SOAH DOCKET NO. 473-19-3864

PUC DOCKET NO. 49421

APPLICATION OF CENTERPOINT § BEFORE THE STATE OFFICE
ENERGY HOUSTON ELECTRIC, LLC § OF
FOR AUTHORITY TO CHANGE RATES § ADMINISTRATIVE HEARINGS

<u>Description</u>	<u>Page</u>
CenterPoint Energy Houston Electric, LLC's Response to Public Utility Commission of Texas Sixth Requests for Information.....	2-89
Certificate of Service	90

Welsh HVDC Schedule

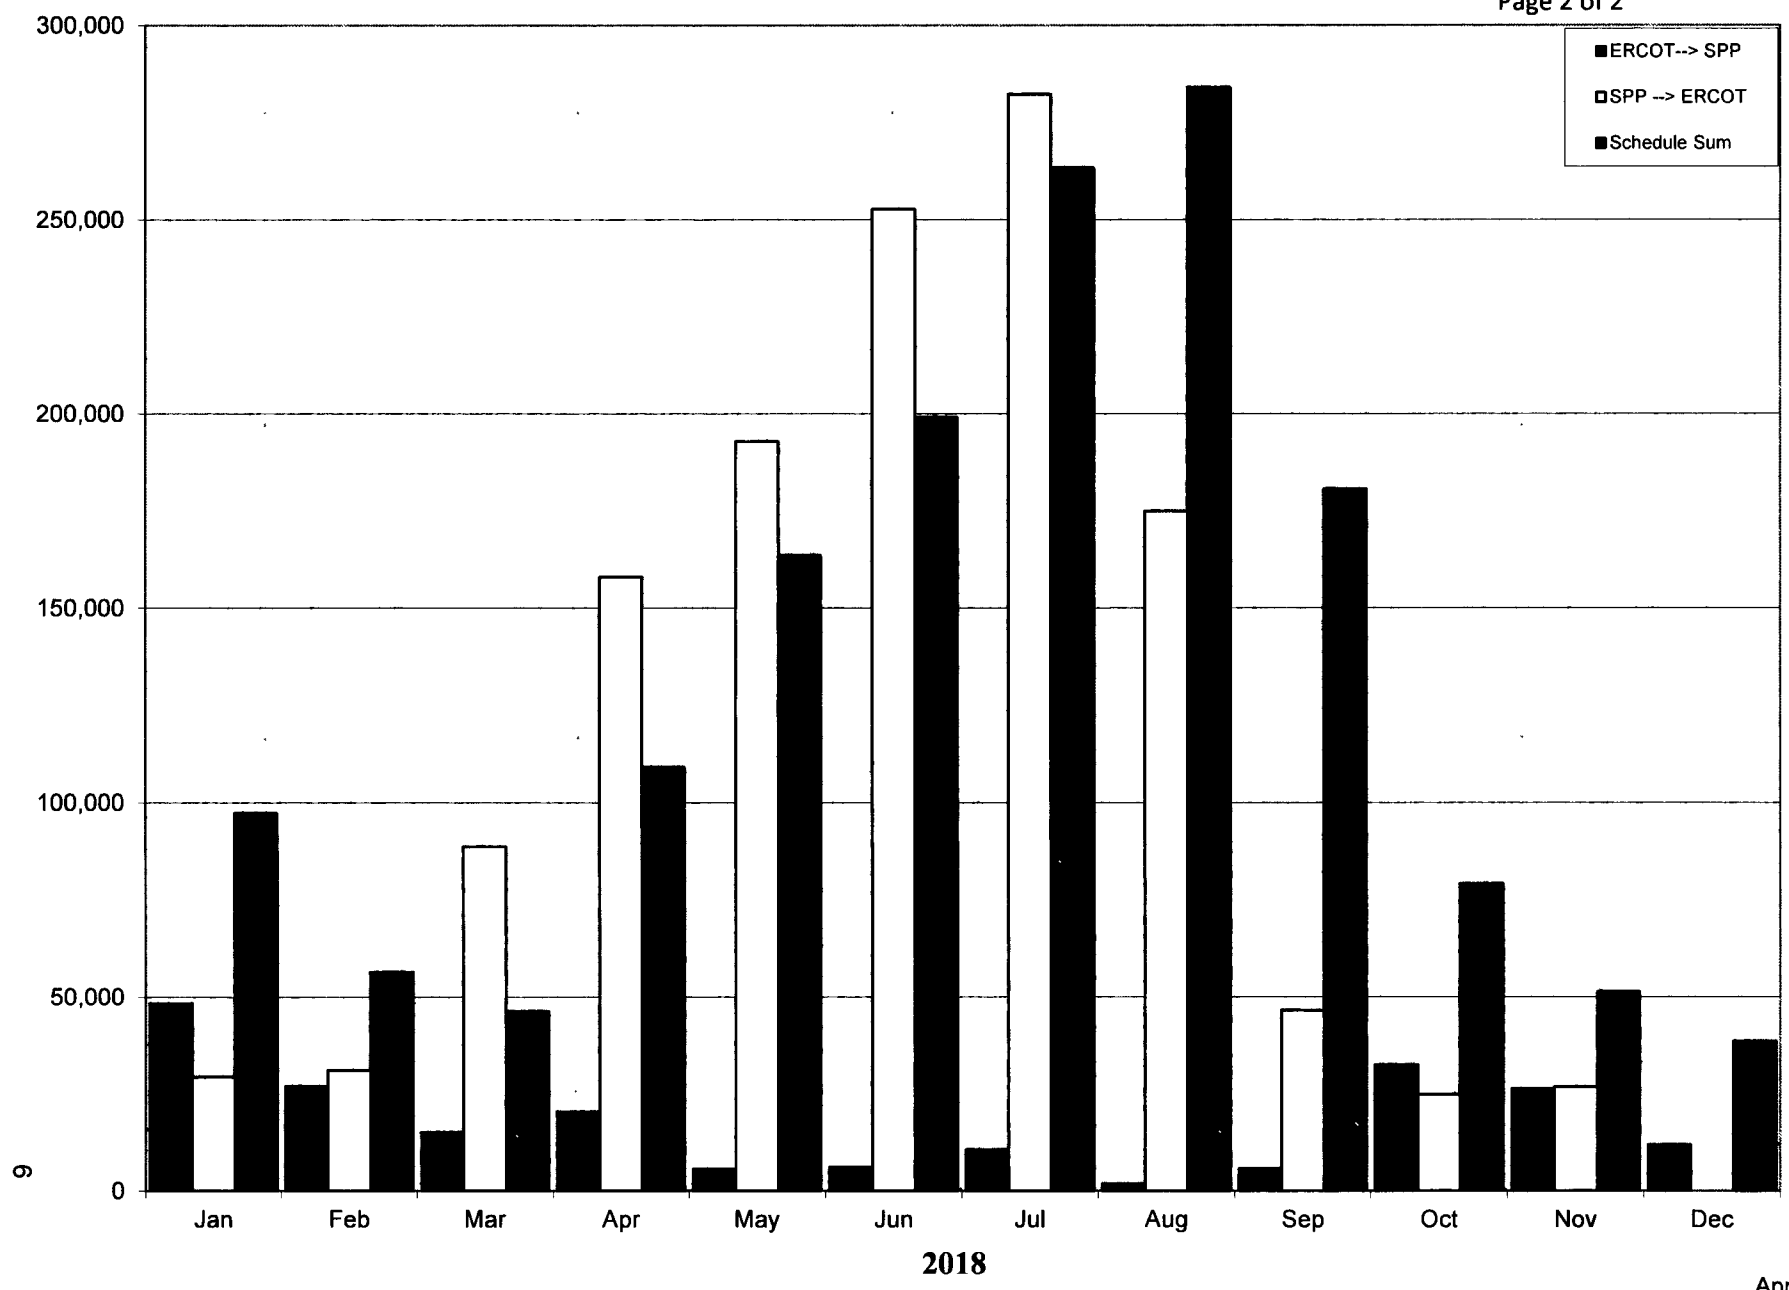
For each month of the Test Year, please provide the peak demand on the Welsh DC tie when the direction of the energy flow was into ERCOT.
